E-3 AWACS
CORROSION PREVENTION ADVISORY BOARD
(CPAB)

12 JULY 1990
TINKER AFB, OK

E-3 CORROSION PREVENTION ADVISORY BOARD MINUTES
12 JULY 1990

Figure 13-13A. Antenna Pedestal Center Section EMP Structural Finishes HCI (Sheet 1 of 10)

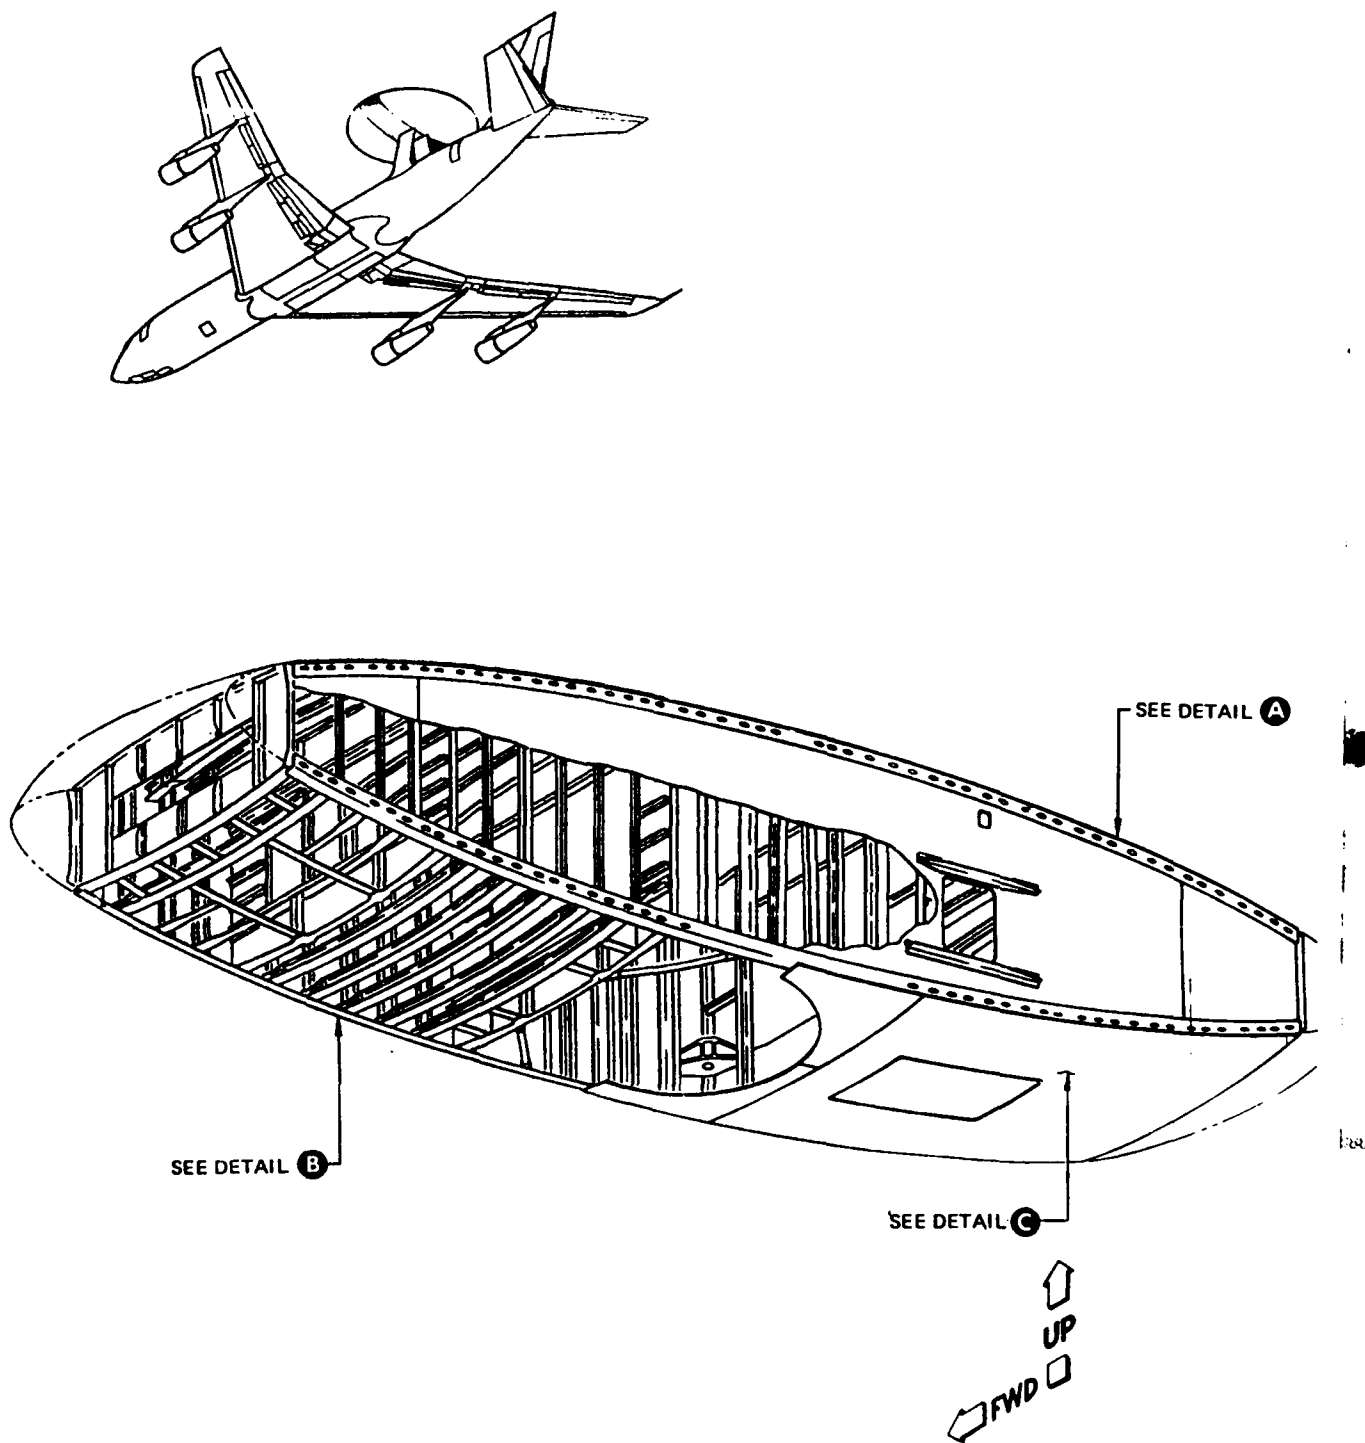
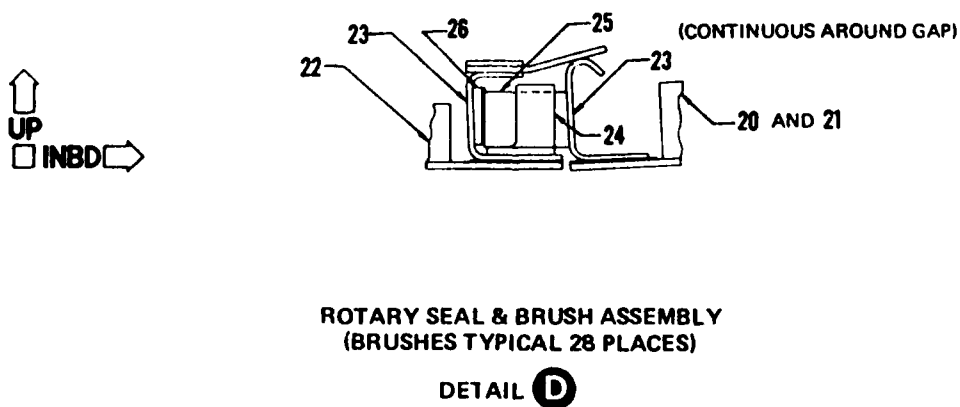
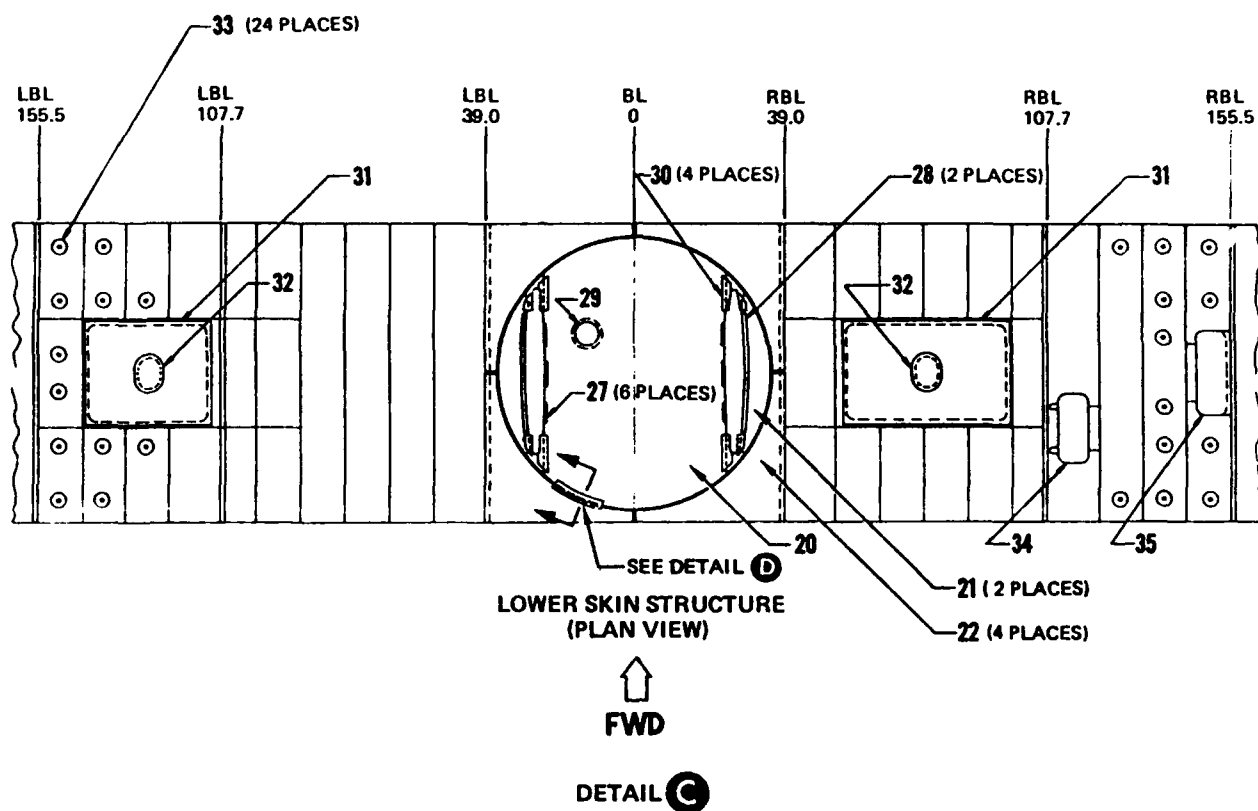
E-3	CORROSION PREVENTION ADVISORY BOARD		ACTION ITEM #: 88-29
O R I G I N A L T O R	SUBJECT: Corrosion on Access Doors in Rotodome Hardback	BACKGROUND DATA: PART NUMBER: 204-20111; 204-20121; 204-20107 NSN: DRAWING(S):	
	NAME: Sgt. Luhm ORGANIZATION: 552d AWACW/MAEB TELEPHONE: (405)733-3826 DATE SUBMITTED:	TO(S): 1E-3A-23 FIGURE: 13-13A INDEX: 31,32 WORK UNIT CODE:	
	PROBLEM: Rotodome hardback access doors have tin plated filler strips mounted to the access doors and the periphery of the structure. Excessive corrosion is reworked and tin strips replaced during phase inspections. These are HCI and are time consuming and costly to repair.		
	RECOMMENDED ACTION: Investigate design configuration and other related corrosion problems in this area. Recommend alternative materials to replace the tin plating. (USE CONTINUATION SHEET IF NECESSARY)		
C P A B A C T I O N	STATUS: May 1989: Boeing evaluated the problem and found the following: 1) Design Configuration (D204-20111): Two differing installations were used on the E-3. Twenty eight aircraft had the access doors installed per 204-20111-1 and -2. Parts made per these dash numbers are tin plated 7075 aluminum frames (204-20107-1 and-2) and fillers (204-20111). Twenty nine aircraft had the access doors installed per 204-20111-31 and -32. Parts made per these dash numbers have cadmium plated 304 stainless steel fillers. (See Figure 4) 2) Effectivity: a) The following aircraft have tin plated filler strips: 1. USAF: 71-1407, 71-1408, 73-1675, 75-0556 through 75-0560, 76-1604 through 76-1607, 77-0351 through 77-0356, 78-0576 through 78-0578, 79-0001 through 79-0003, 80-0137 and 80-0138. 2. NATO: 79-0442 and 79-0443 (continued)

3. Repair: The -31 and -32 installations may be repaired per T.O.1E-3A-3-1 Section VII Paragraph 7-12 and Figure 7-9. This procedure may also be used to convert the -1 and -2 installations to the -31 and -32 installations. This will provide better corrosion protection.

Users will provide complete inspection results to OC-ALC/MMKRA. OC-ALC/MMKRA will investigate providing a kit for configuration change on A/C 79-0442 and 79-0443 to Cad plated stainless steel.

Boeing reported that the reason for configuration change during production was due to corrosion of the tin plating.

552 AWACW has not completed inspections of access doors. MMKRA will coordinate a TCTO with MMKRTA to change tin plated filler strips on USAF and NATO aircraft.

The replacement of aircraft with tin plating filler strips will be done by attrition in accordance with T.O. -3-1. 552 AWACW prefer TCTO to be generated because the fillers will corrode eventually. MMKRA will take action to investigate TCTO.

552 AWACW has not inspected cad plated filler strips for corrosion on aircraft noted in May 1989 status.

FIGURE 5: JOINT LOCATIONS

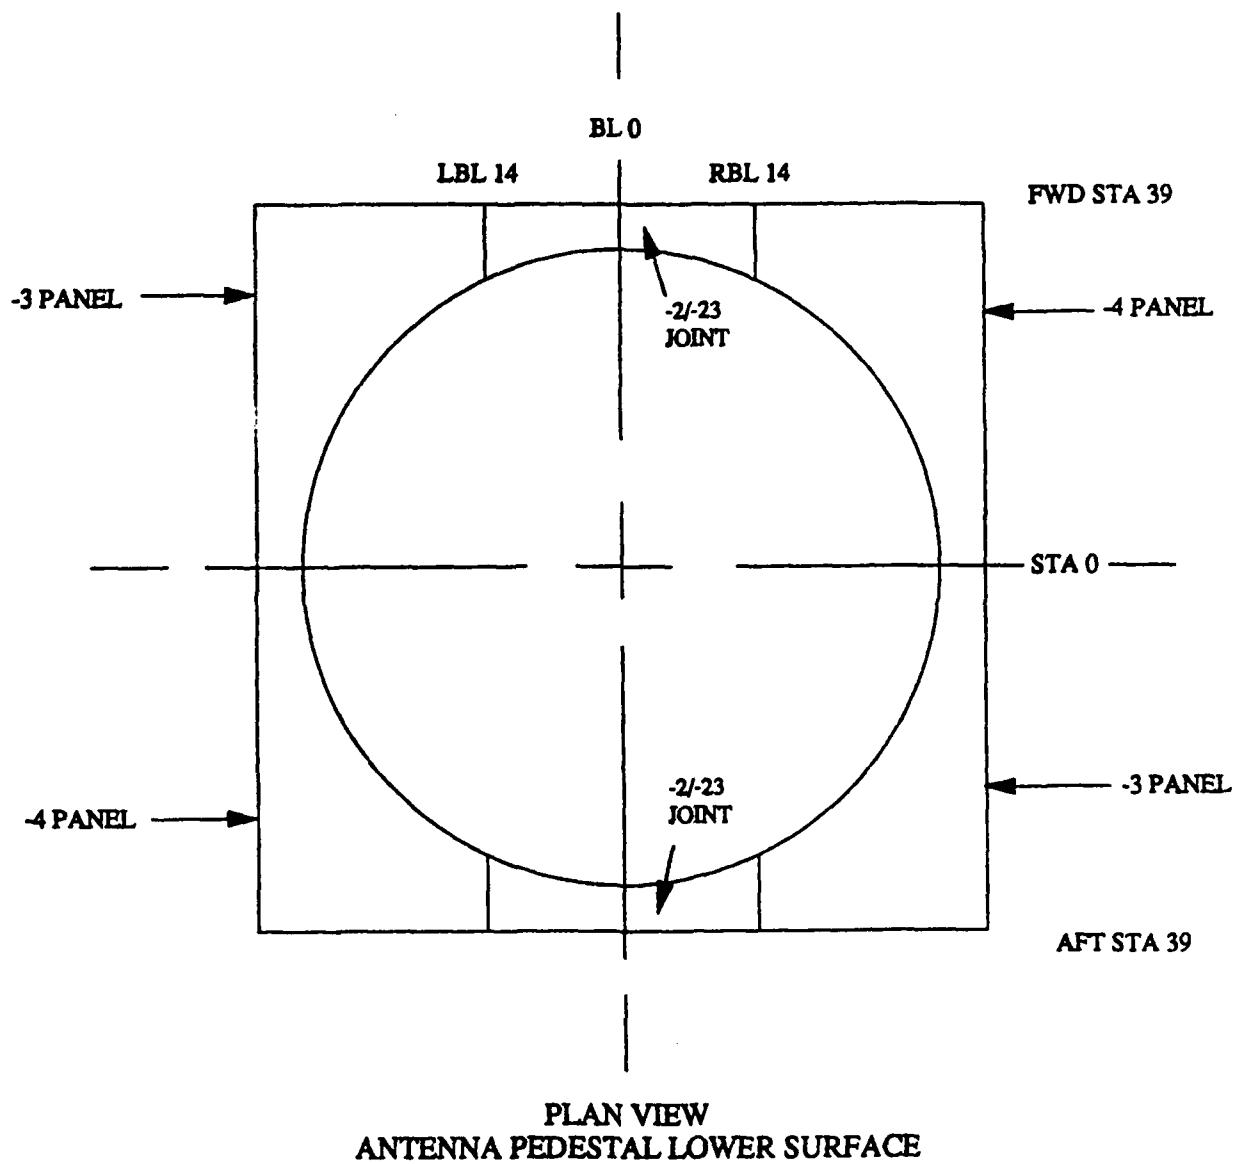
A/C 79-0459 No corrosion between splice plates and closure panels, but tin plated surface of the closure panels on several places corroded. Filler panels show discoloration.

MMKRA will add rework procedures to the appropriate tech orders. Tech data will be updated to reflect proper configurations and part numbers.

No action has been taken by MMKRA to add rework procedures or prepare ECO to change material or dash number. Action will be complete prior to next CPAB.

All actions not yet completed by MMKRA. No ECO will be issued to change part numbers. Part number changes done by Boeing only. Tech Orders will be changed to require local fabrication of new parts during rework using chemically treated Clad 7075 aluminum.

Figure 2-5. Fillet Flap Flaperette Corrosion Inspection Guide (Sheet 1 of 2)

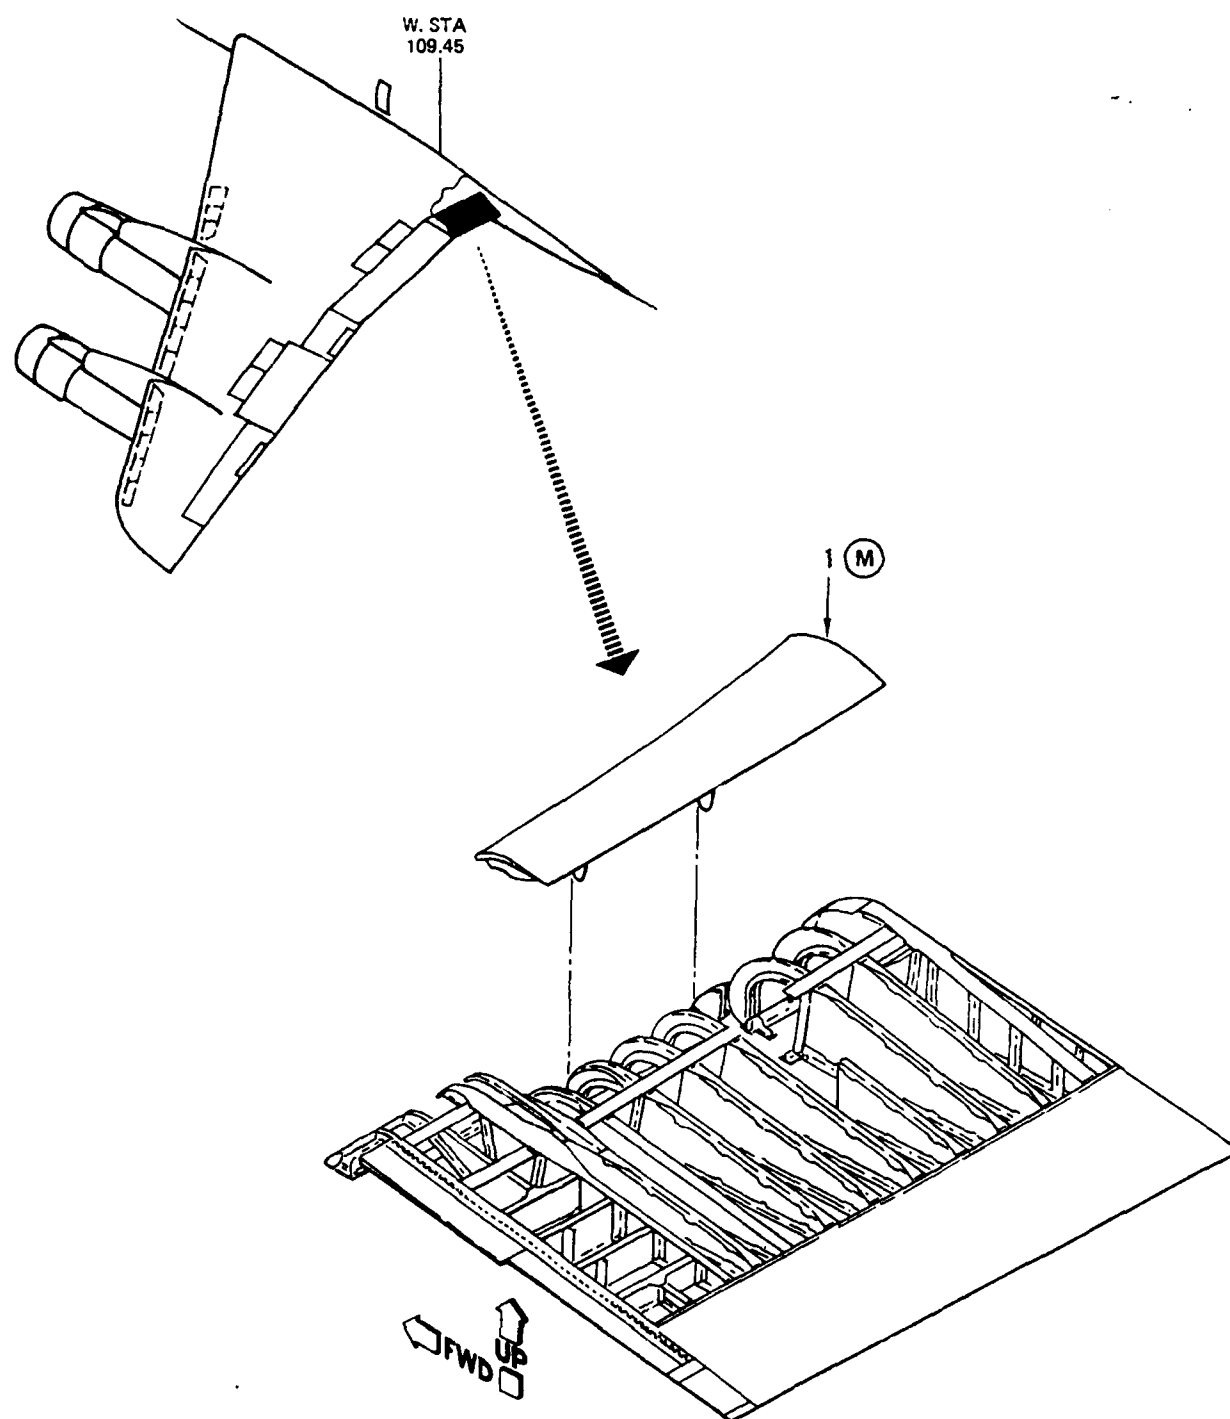
E-3		CORROSION PREVENTION ADVISORY BOARD		ACTION ITEM #: 88-31	
O R I G I N A L T O R	SUBJECT: Fillet Flap Flaperette Corrosion		BACKGROUND DATA:		
			PART NUMBER: 65-19178		
			NSN: DRAWING(S):		
	NAME: Josef Deckers ORGANIZATION: NAEWF/Comp/LWMQ TELEPHONE: 49 2451-63-363 DATE SUBMITTED: 15 NOV 1988		TO(S): 1E-3A-23; FIGURE: 2-5 INDEX: 1 WORK UNIT CODE:		
	PROBLEM: The brush seal that contacts the upper surface of the flaperette seems to be holding moisture and contaminants and causing corrosion on the upper forward surface of the flaperette.				
	RECOMMENDED ACTION: Determine purpose and material of the seal, suggest alternatives to the seal and/or determine if better finish requirements are needed to protect the flaperette underneath the seal.				
	(USE CONTINUATION SHEET IF NECESSARY)				
C P A B A C T I O N	STATUS:				
	Jan 1989: Abrasion resistant teflon coating could be applied to the flaperette to add an additional layer of corrosion protection and chafing protection.

May 1989: MMKRA will change T.O. 1E-3A-23 to require finishing the flaperette with teflon coating.				
	BOEING will provide procedures for applying the abrasion resistant teflon coating to the flaperette.				
	Nov 1989: Brush seal is made of mohair and is an aerodynamic seal. EST 89-E3B2-13 is a task to Plastic Media Blast (PMB) various magnesium parts. This part is one which will be PMB'd. After blasting, it will be repainted with teflon coating added. At this time procedures for applying the coating will be developed. (continued)				
	ACTION OPR(S): BOEING/MMKRA		POINT(S) OF CONTACT: Richard Elmslie/Vince Foster		EST. COMPLETION DATE:
STATUS: OPEN DATE CLOSED: FINAL DISPOSITION:

NAEWF E-3A Component will perform a normal prepaint surface treatment and add teflon coating to test the adhesion and wear characteristics, and will report results at next CPAB.

Once field tests are completed by E-3A Component, OC-ALC/MMKRA will include instructions to apply teflon coating after corrosion rework in T.O. 1E-3A-23, Figure 2-5 Corrosion Inspection Guide.

NAEWF E-3A Comp. reported that A/C -0456, treated with Lixton compound with teflon coating on 30 Nov., is in good condition when inspect on 30 June. Another aircraft treated the same way on 30 Dec. is also currently in good condition. So far, the coating is adhering to the surface with Lixton. A/C -0457 will be similarly treated soon.

Figure 13-16. Abrasion-Resistant Teflon Coating Locations (Sheet 5 of 6)

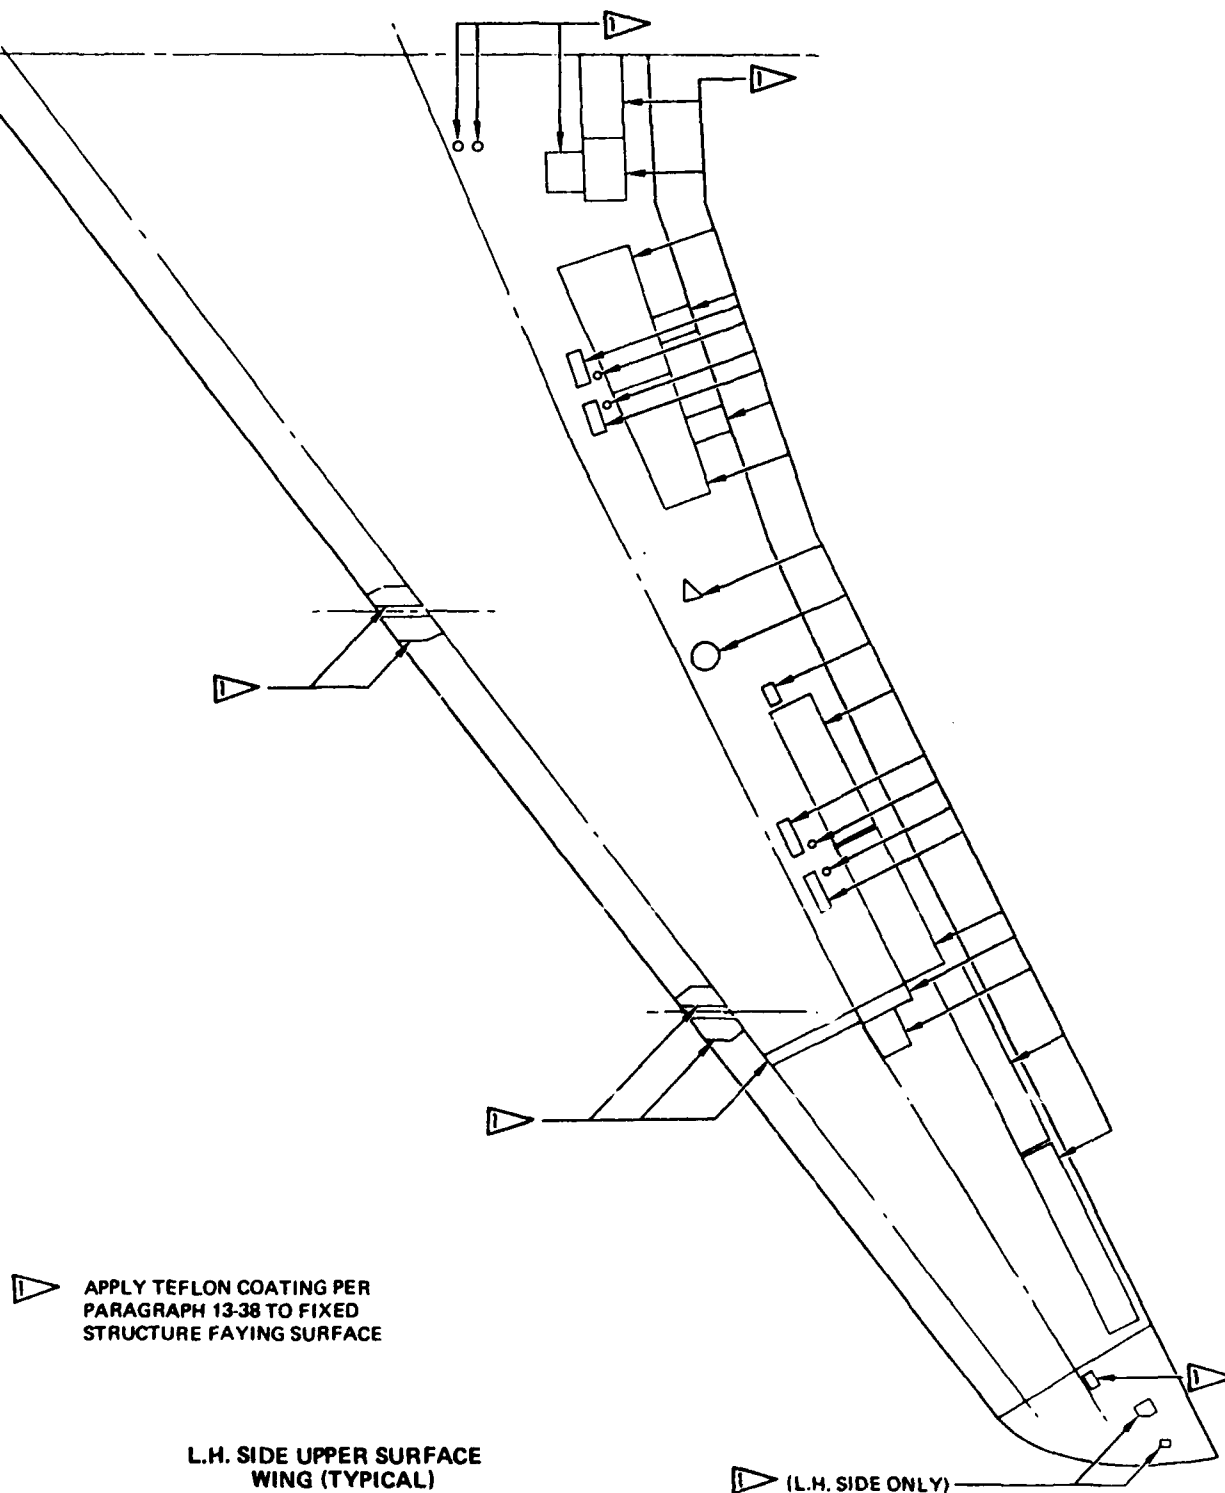
E-3		CORROSION PREVENTION ADVISORY BOARD		ACTION ITEM #: 88-32	
O R I G I N A L T O R	SUBJECT: Abrasion Resistant Teflon Coating on Faying Surfaces		BACKGROUND DATA: PART NUMBER: 7-W-27 or 7-X-74 NSN: DRAWING(S):		
	NAME: HFW Franz-Josef Deckers ORGANIZATION: NAEWF E-3 Comp. TELEPHONE: 01-49-2451-63-6215 DATE SUBMITTED: 15 NOV 1988		TO(S): 1E-3A-23 FIGURE: 13-16 ; para. 13-38 INDEX: entire figure WORK UNIT CODE:		
	PROBLEM: Teflon coating is applied on faying surfaces during manufacture to prevent fretting. The areas of application listed in T.O. 1E-3A-23 fig. 13-16 are incomplete. Requirements for inspection and replacement of the teflon coating are non-existent.				
	RECOMMENDED ACTION: Ensure reapplication requirements are included in tech data, and ensure figure 13-16 is updated to include areas in engine cowlings, nacelles, and fuselage that require teflon coating reapplication. (USE CONTINUATION SHEET IF NECESSARY)

Statement of work for a Boeing EST has already been submitted by MMKRA. Procedures for application are available in T.O. -23.
